Item 2D – Change Order: Additional Compliance Measures for Constructor Role and Unforeseen Conditions to the Envelope Repairs and Structural Rehabilitation Project at Mornelle Ellsemere

TCHC February 26, 2021 Board Meeting

Report #: TCHC:2021-02

ATTACHMENT 1 – SITE PHOTOS

<u>Image 1:</u> Example of the current conditions of the structural reinforcement at the balcony slabs. Once uncovered, it was revealed that portions of the steel reinforcement required replacement, as well as a coating to prevent continued deterioration and rusting.

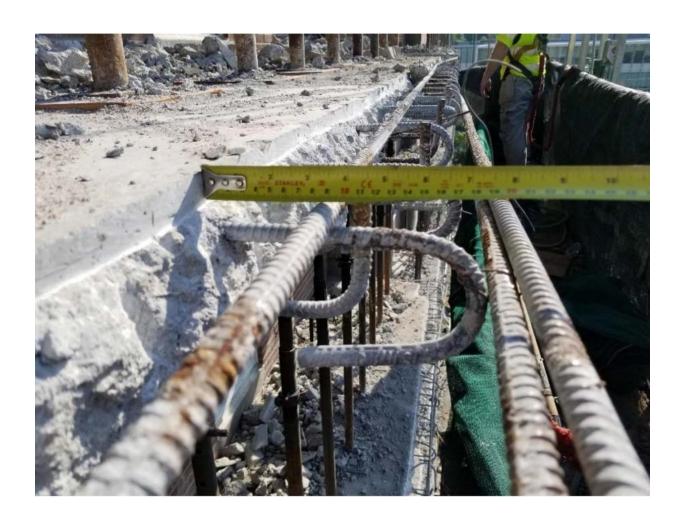
Reason for change – Unforeseen site condition
